SLF 51/3/4
9 May 2008
Original: ENGLISH

DEVELOPMENT OF EXPLANATORY NOTES FOR HARMONIZED SOLAS CHAPTER II-1

Consideration on the requirements for pipes piercing the collision bulkheads

Submitted by the International Association of Classification Societies (IACS)

Fig.1

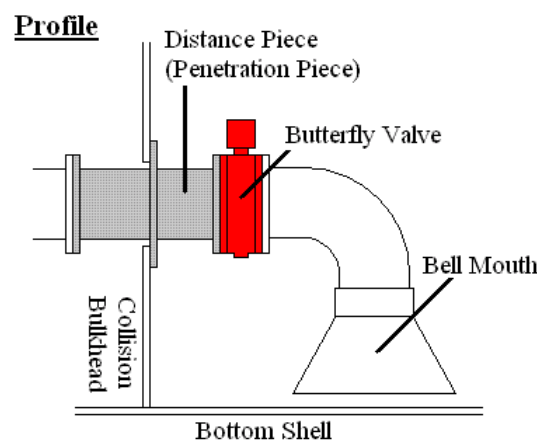
3 In current designs of cargo ships, butterfly valves, generally secured to the bulkhead structures by penetration pieces, are widely used as bulkhead valves and, as permitted by SOLAS, as skin valves for overboard pipes, for the following reasons: (See Fig.1 below)

7 Valve arrangements shown in Fig.1 to Fig.3, above, have been accepted under current SOLAS. The use of a short penetration piece was, and still is, considered as the only practical way of achieving compliance with the requirement that the "valve chest shall be secured at the bulkhead inside the forepeak".

9 On the other hand, valve arrangement secured to the bulkhead structures by short penetration pieces as shown in Fig.3 as well as that shown in Fig.1 are considered to provide an acceptable arrangement and should be acceptable under SOLAS regulation II-1/12.5.1 as amended by resolution MSC.194(80).

Fig.2

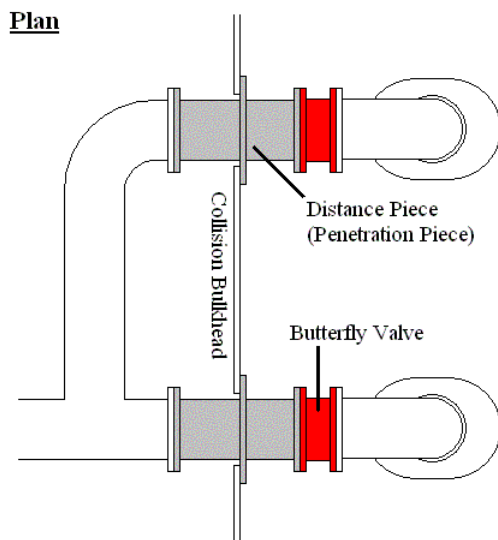
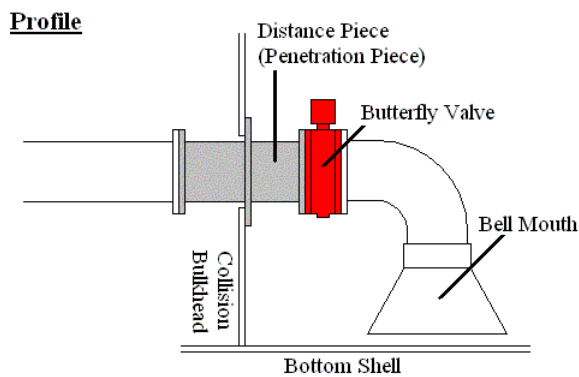
4 For large ships, it is frequent that two discharges are provided in accordance with ship operators' request, since it is very difficult to discharge water from a large fore peak tank that is provided with only one discharge having a valve located within the tank. Also, two valves provide redundancy in the event one were to fail. Typical piping arrangements are shown in Fig.2 and Fig.3 below. In these cases, the bulkhead valves are secured to the bulkhead structures (e.g., vertical webs of the bulkheads) by penetration pieces and/or short branch pipes.

8 It is clear that there is no room under the provisions of regulation II-1/12.5.1 of the amended SOLAS to permit the valve arrangement shown in Fig.2 for minimizing opening in the collision bulkheads.
